SUBJECT: Transmittal of Revised Responses to AP1000 DSER Open Items

AP1000 Design Certification Review
Draft Safety Evaluation Report Open Item Non-Proprietary Responses

AP1000 DESIGN CERTIFICATION REVIEW

DSER Open Item Number: 15.3-1 Response Revision 5

Figure 1: MAAP4 Containment Temperature for Sequence 3BE-1

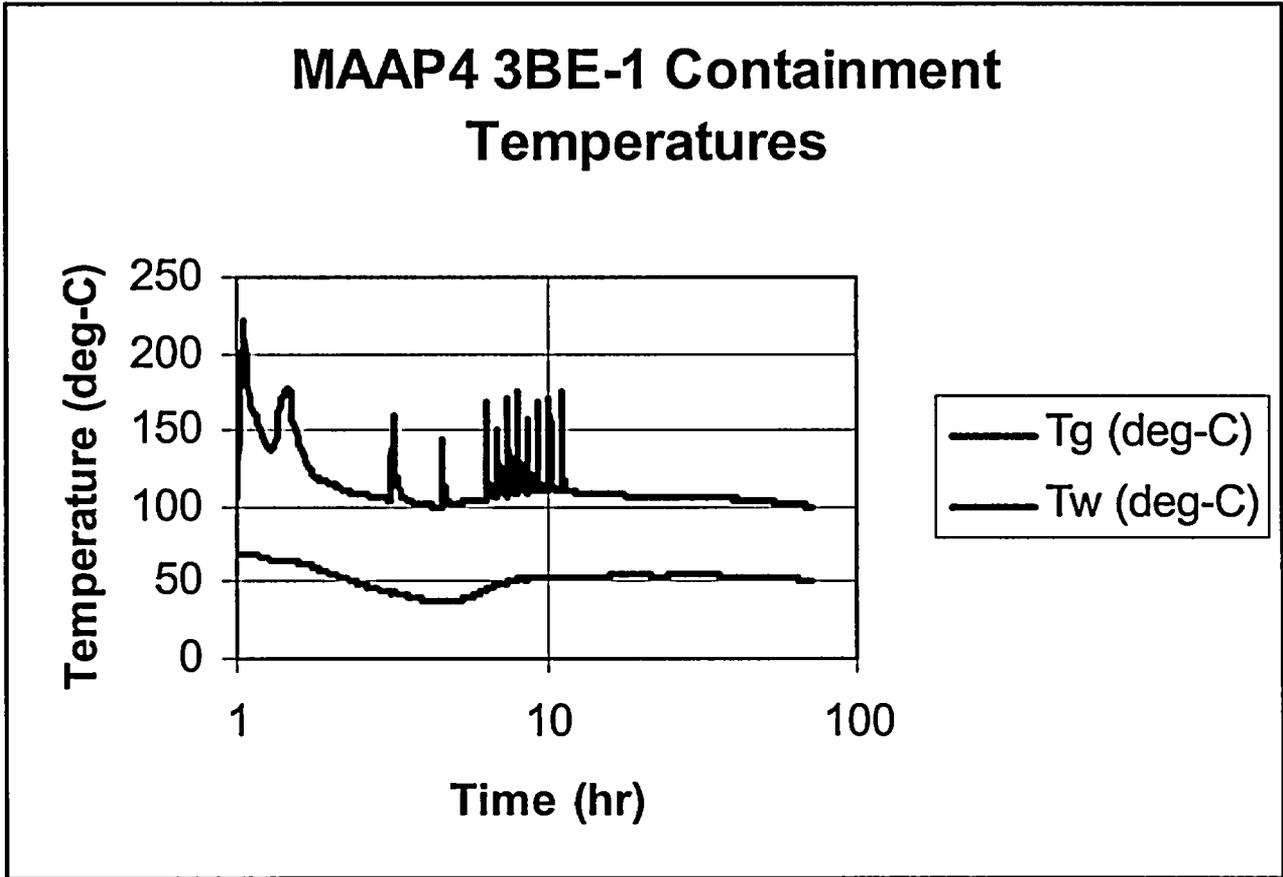
- a) Provide additional justification for aerosol removal by thermophoresis. In particular, address how the heat transfer rate from the air to the containment wall is calculated and applied in the determination of aerosol removal by thermophoresis.
- b) The particle density fraction (0.8) and void content (water) used by Westinghouse are not sufficiently conservative; NRC would agree with particle density fraction of 0.6 and void content of air.

Only convection heat transfer should be used in determining the lambda due to thermophoresis.

The convective heat transfer to the containment shell was determined from the MAAP4 simulation of sequence 3BE-01. The containment gas temperature and the film temperature on the wall are shown in Figure 1 for this sequence. Figure 2 shows the temperature difference between the gas and the film which is the driving mechanism for heat transfer. Figure 3 shows the MAAP4 calculated convective heat transfer to the film on the containment inner surface.

AP1000 Lambda for Sequence 3BE-1
(release at 3300 seconds after event initiation)

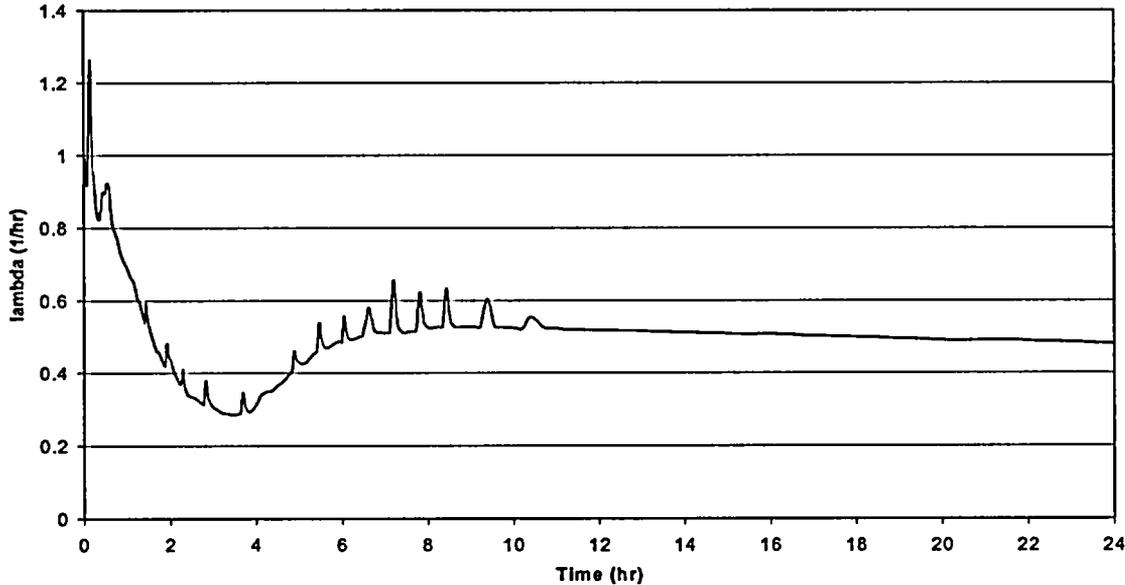
Explain the long term trend of the overall lambda for AP1000 as compared to that for AP600.

The overall aerosol removal coefficients (λ) calculated by STARNAUA are shown in the figure below. These removal coefficients are used in the LOCA dose analysis to determine the offsite and control room doses.

It is noted that the AP1000 overall lambda decreases only slightly after about 7 hours out to 24 hours. For AP600 the overall lambda decreased about 10% over this time period. This difference is assessed as follows.

Lambda Breakdowns for the Case In Which Gap Release Starts 3300 Seconds

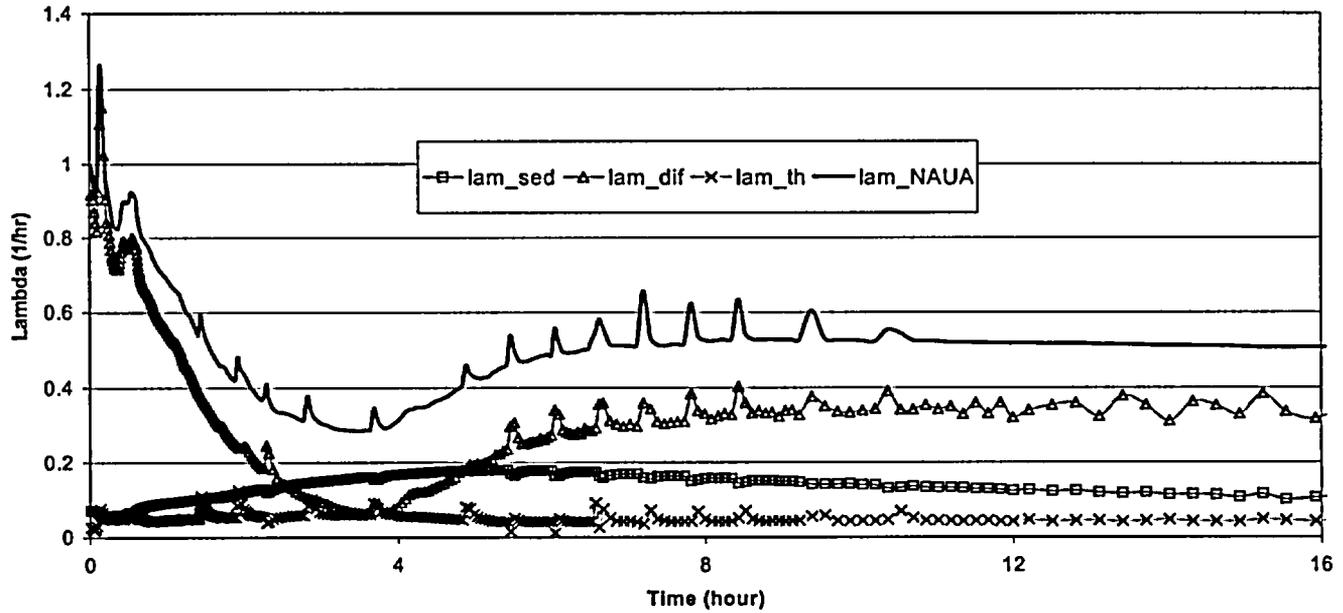
Provide a breakdown of contributions to aerosol removal as a function of time, and provide the total aerosol concentration as a function of time.

The following two figures provide STARNAUA results for lambda elements and for aerosol particle concentration in containment atmosphere.
